TOWN OF SMITHFIELD

**TOWN OF SMITHFIELD
BOARD OF HISTORIC & ARCHITECTURAL REVIEW
AGENDA**

November 15, 2016

**STAFF REPORT FOR
BOARD OF HISTORIC AND ARCHITECTURAL REVIEW**

SECTION & DETAILS

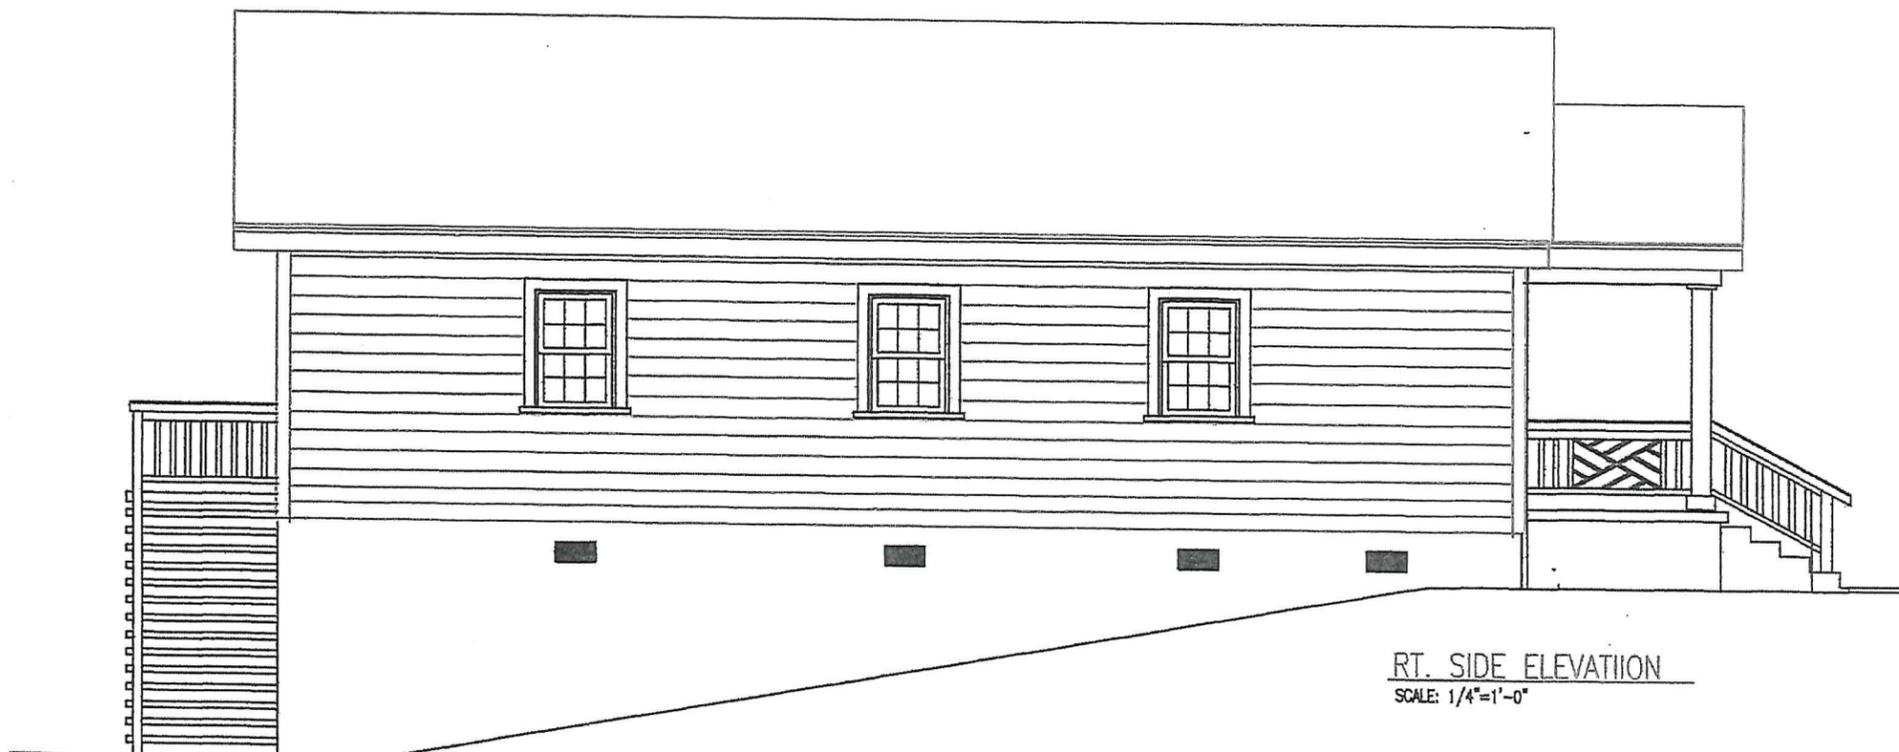
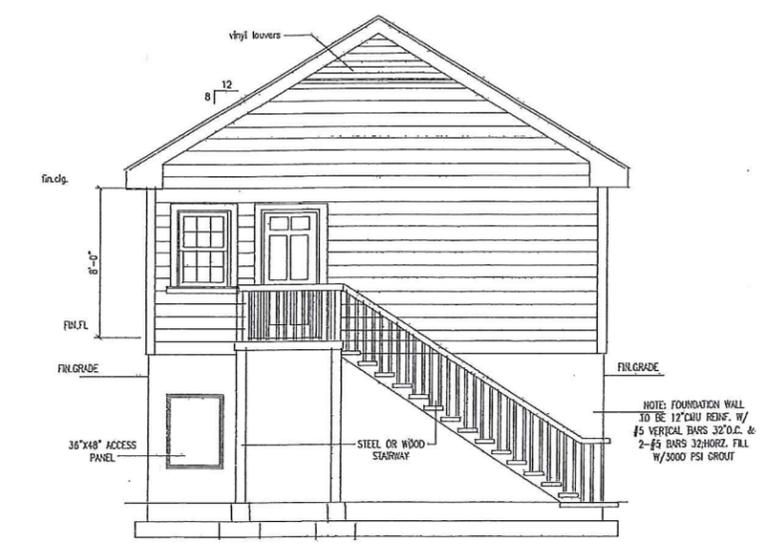
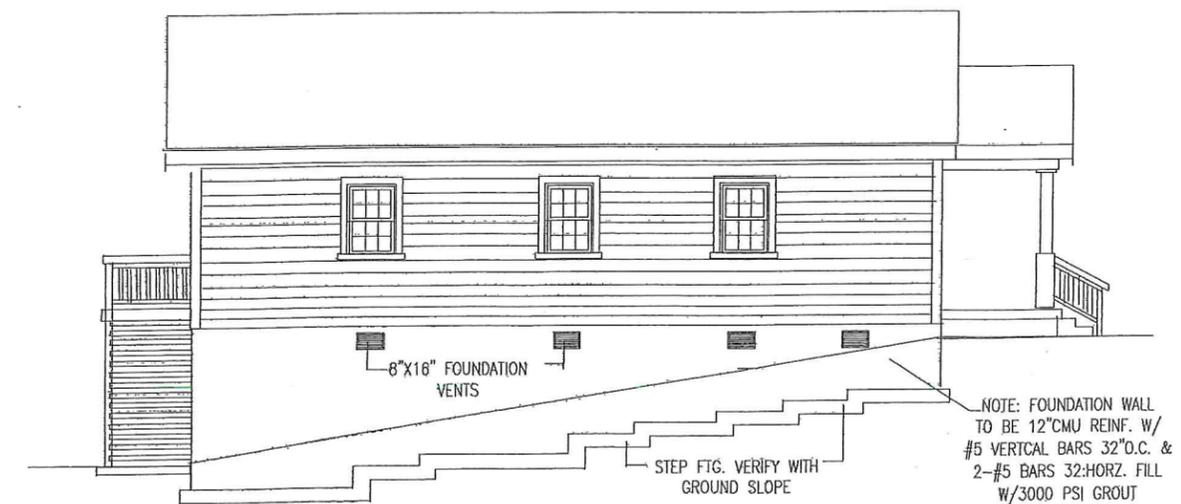
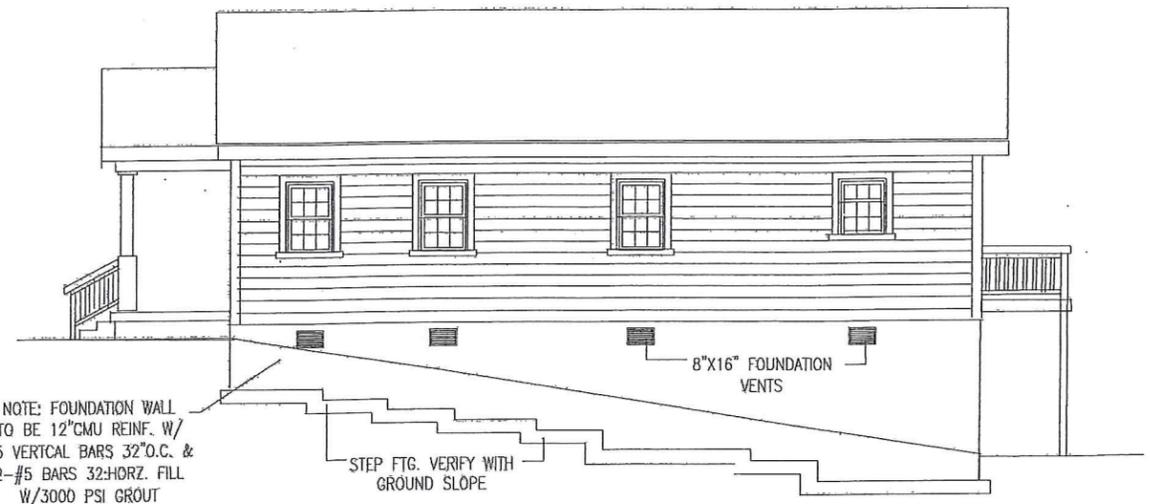
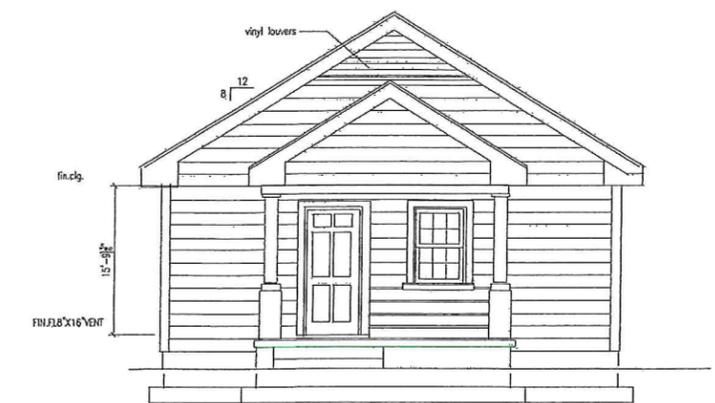
On September 20, 2016; the Board of Historic & Architectural Review (BHAR) approved the proposed demolition and replacement of the home at 222 Astrid Street as presented with the following condition: that the front porch be redesigned in a style more representative of the existing craftsman porch and resubmitted to the Board for final approval.

Please find enclosed the original and revised renderings. The new columns will be square atop square brick bases. The railings for the front porch stairs will be treated wood, painted white, with 1" x 1" pickets.

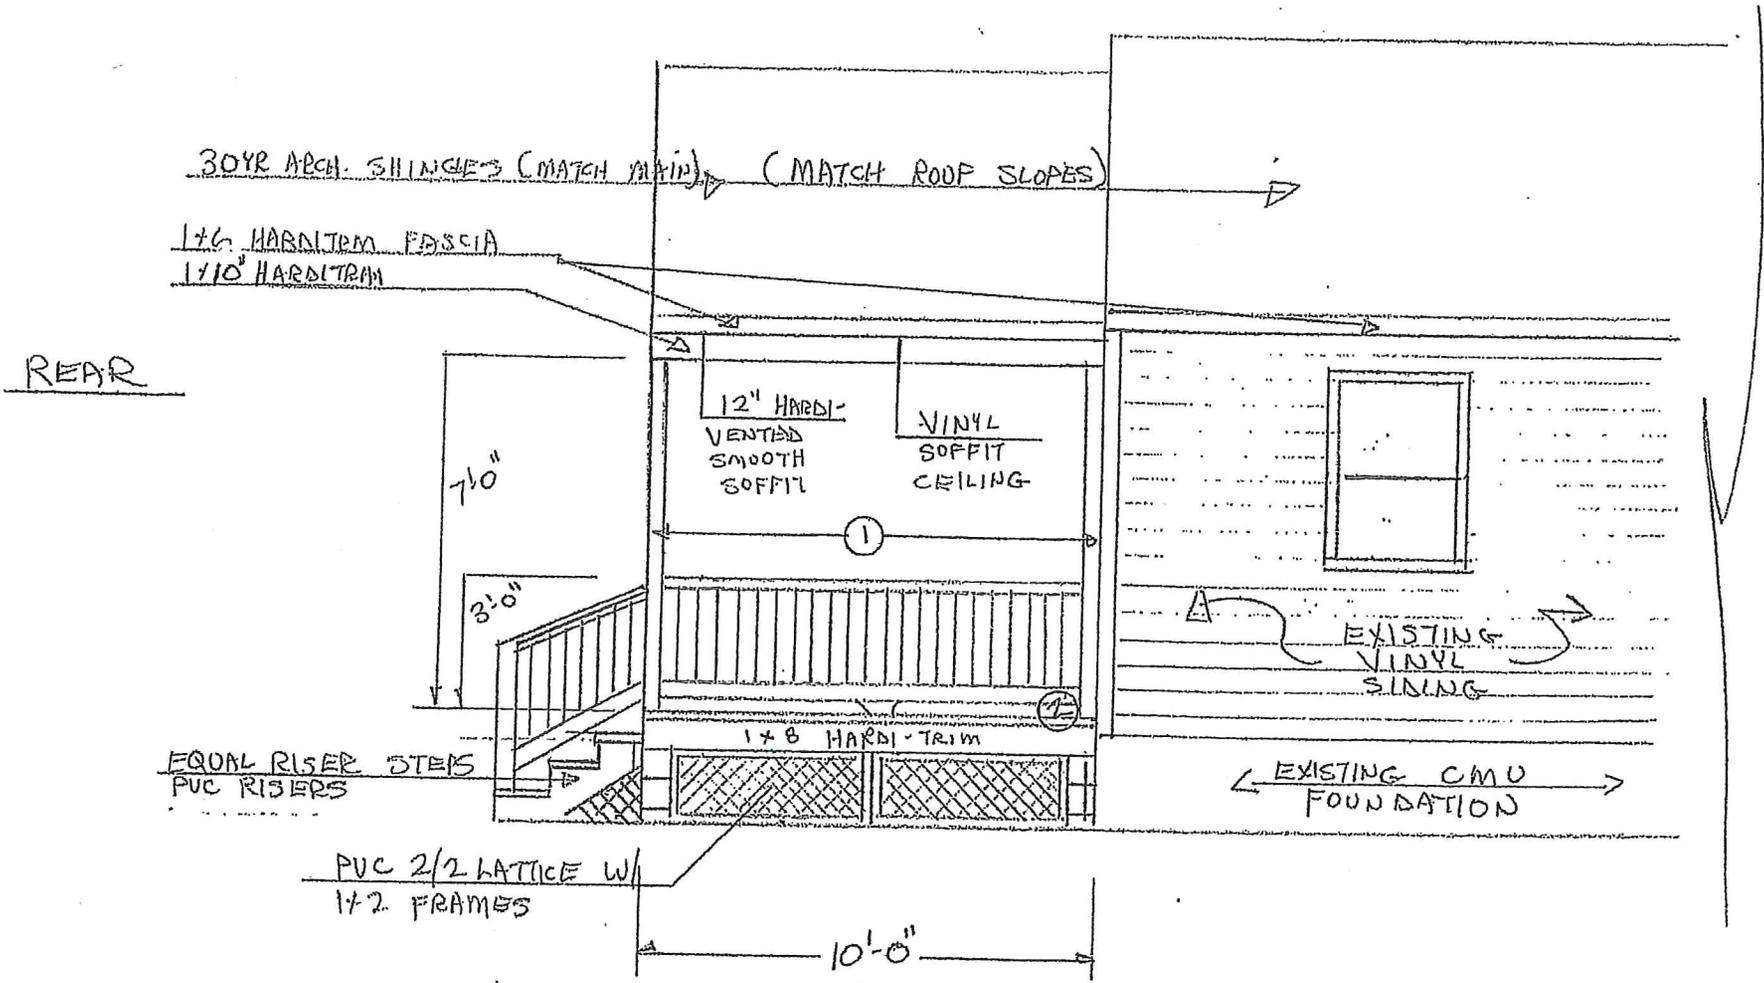
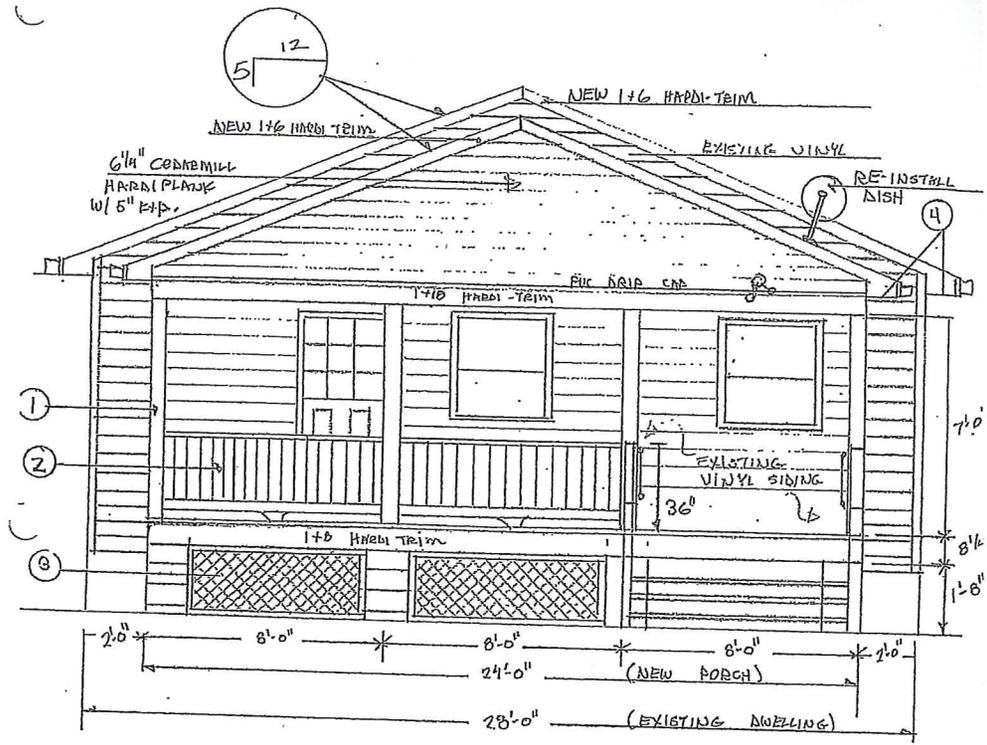
The applicant wishes to receive BHAR approval to revise the December 16, 2014 approval of the rear porch railings. On that date, the BHAR approved a rear porch rebuild that included railings that were to be Fir 'Richmond Rail' with 1" x 2" pickets in white. The contractor, not being able to locate this item, installed treated pine railings with a 2" x 4" hand rail and treated pine 1" x 1" pickets, intending to paint them in white.

The applicant seeks approval after the fact to use the railings that have been already installed.
